Bulletin

Application: Saturn TAAT
Subject: Valve Body Gaskets

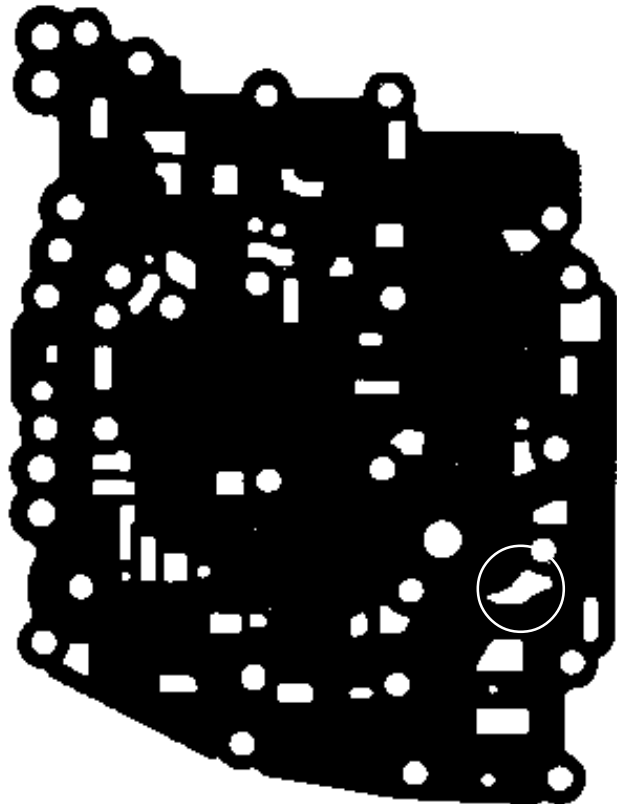
TransTec has used only one set of gaskets, TransTec #12523, to cover all late 1992 and later units. It has been brought to our attention that using these gaskets on the late 1997-up valve body assemblies can potentially create a cross-leak if not installed carefully.

In light of this information, we have added the 1997-up gaskets to all TransTec kits. The part number is **12291**. The 1997-up gaskets are very similar to the 1992-96 gaskets (TransTec #12523), with the only difference being the shape of one hole. See illustrations below.

1992-96, TransTec #12523 (OEM #21002390)

1997-up, TransTec #12291 (OEM #21003530)
